# APPENDIX ZD

## ADDENDUM TO NOBLE DENTON MARINE SERVICES REPORT TO SPIRIT ENERGY REPORT REVIEW OF MARINE HAZARDS (DECEMBER 2018)

<b>Date:</b>	14 <sup>th</sup> December 2018	<b>Ref:</b>	TN – 777	<b>Rev:</b> 0
<b>Project No:</b>	10074959 Task 60	<b>Client:</b>	Spirit Energy	
<b>Attn:</b>	Max Rowe			
<b>Author:</b>	Robert Sinclair	<b>Checked:</b>	Sujit Viswanathan	
<b>Subject:</b>	Addendum to Report A 13423 Rev 3 – Review of Marine Hazards – Hornsea 3 Windfarm

Figure 2: (Extract from Figure 7.3 of above document) - Overview of existing marine traffic survey data

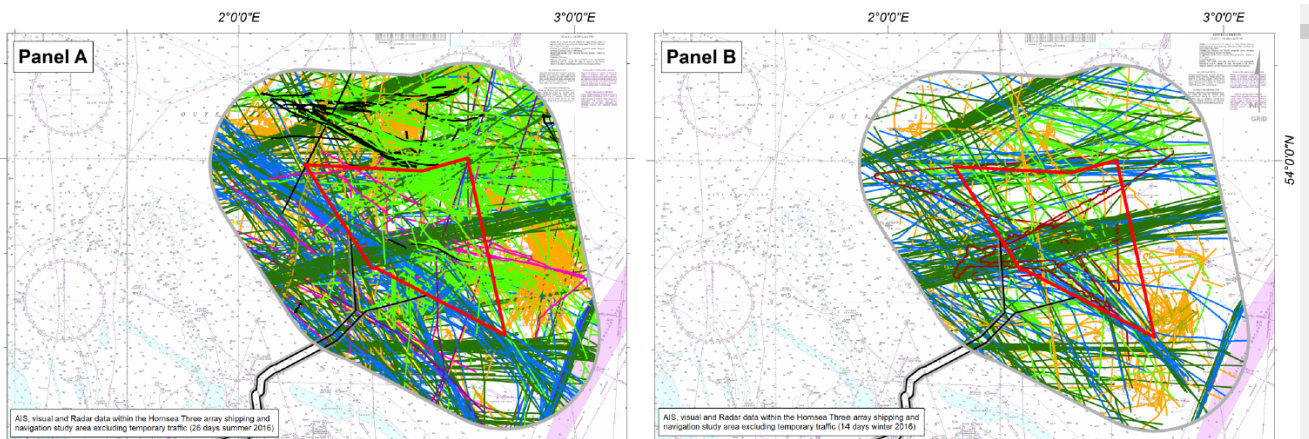
The above figure shows an output from the traffic surveys undertaken in summer and winter 2016. This shows the area immediately west of the existing offshore infrastructure to be heavily trafficked by a range of vessels. It is noted that this also excludes temporary traffic – and only 40 days summer and winter 2016 are considered and so is not considered a realistic basis for assessment. The document then goes on to list a large number of wind farms which have either been recently made operational, are under construction, consented or are applied for in the Southern North Sea. The combined area of Hornsea 1, 2 & 3 alone, is much greater than existing windfarms in UK waters, in addition to the numerous others. As much as Spirit Energy have indicated that they do not object in principle to the Application, their concern in this case is the proximity of the proposed eastern boundary to Spirit Energy’s assets, and the impacts this development, combined with the numerous others has on traffic flow and hence has on the risk of vessel collision with existing offshore infrastructure and activities. The additional burdens of managing these risks, under its obligations as per the UK Safety Case Regulations, is also of consideration.

Therefore, it is not credible to consider that the traffic indicated in Figure 2 above, with the addition of Hornsea 1, Hornsea 2, and Hornsea 3 is projected to translate into no or no additional traffic passing close to Spirit Energy assets at the 90th percentile level (areas within which 90% of vessel traffic transiting a route are situated as per MGN 543).
